Dixie Mine, M-2015-028, Technical Revision No. 2 (TR02), Adequacy Review

**RE: M2015-028, Technical Revision (TR-2), Adequacy Review No.1
Response**

Photo 1 - Working Pad, Trench Area and "Highwall"

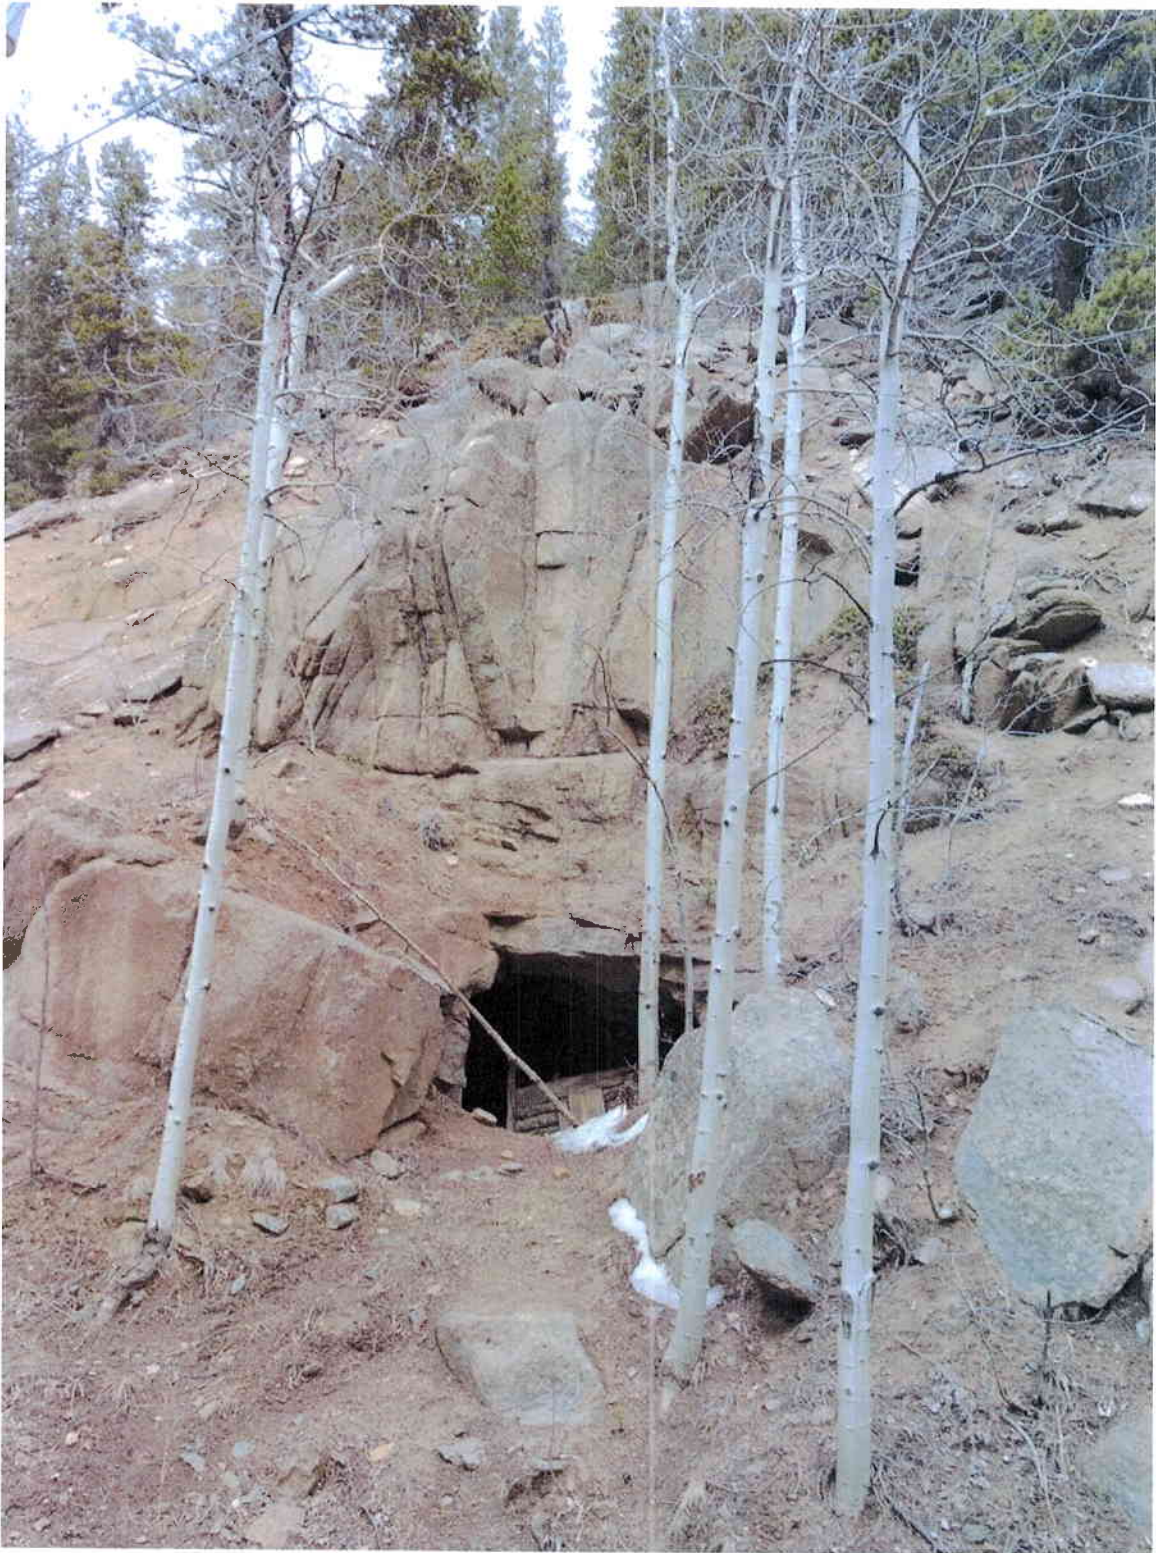
2. *"The Division's July 26, 2018 inspection report indicated the Operator had created a working pad area to facilitate the excavation of the trench. In creating the pad area, a two hundred foot highwall was created about 15 to 20 feet in height. This pad area and highwall was not discussed in the submitted technical revision. Please add a section to the mining plan to include the creation of the pad area. Please submit an updated Mining Plan Map in accordance with Rule 6.3.5(2) depicting this pad area."*

5. *“Page 2 of the mining plan indicates that rocks of sufficient size and character may be stored and sold separately as by-product of the operation. If a significant amount of this type of material is removed this could impact how the site is reclaimed particularly in regards to the post mine topography. If a highwall is planned to remain on the site please supply an engineering stability analysis for the proposed final reclaimed slopes/highwall in accordance with Rule 6.5(2). If enough material will remain on site to eliminate and grade the highwall, please commit to this.”*

The "two hundred-foot highwall" is not part of the working pad, but rather the uphill hillside adjacent to the vein trenching (mining). The pad area is included in Exhibit E, Map #2, submitted in the original permit application and discussed in the original permit adequacy review submittals as part and parcel of the mining method (using a hydraulic excavator and its necessary working platform on such a steep slope). As a result of this, Teton did not include additional information in the requested Technical Revision. If necessary, to provide clarity to the DRMS, Teton would like to meet with you, on site at your earliest convenience, to discuss the reclamation, mining method and how the DRMS would like this documented in the permit and Technical Revision.

The “highwall” will remain in place and is analogous (but smaller) to the existing and long-established rock cuts in the Ute Creek and Viking roadways immediately below the property. These rock cuts, and the many cliffs and rock outcroppings are prima-facie evidence of the stability of the rock underlying the entire Ute Creek drainage. It is Teton’s plan to excavate to solid rock (as has been shown in Photos 4, 5, & 6, below) and for this short rock face to remain, without additional reclamation. This rock face will be congruent with the steep, rocky topography of the Ute Creek drainage and is extremely unlikely to require any further stabilization. Teton believes that the obvious short (~15 feet) height of the final rock face, the obvious stability of the rock in the numerous faces, both naturally eroded and human excavated, obviate the need for an expensive engineering analysis.
